NABI Service Bulletin: SB-12-17-01

Subject: Fan Drive Belt Maintenance

Date: November 30, 2012

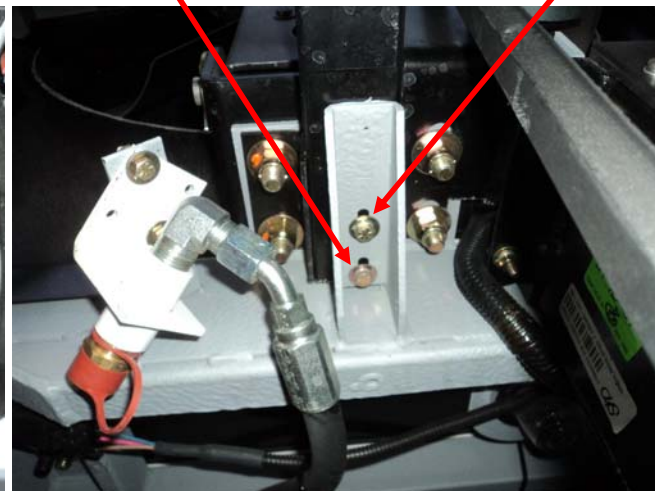
On the NABI buses equipped with Cummins engines, starting with NJT fleet # 6164, the curb side **removable** support beam is now also bolted underneath to the main structure. Upon completion of the fan support bracket campaign (L3-FSV-118) for buses built prior to NJT fleet #6164, all NABI buses equipped with Cummins engine will be the same. The belt replacement and tightening procedure is the same as it was before, except to remove the support beam, the two lower ¼-20 hex head bolts must also be removed (see pictures below). When reinstalling the bolts, apply anti-seize compound to the ¼-20 grade 8 bolts and torque to 95 lb-in.

Removable support beam

New ¼-20 Gr. 8 bolts added
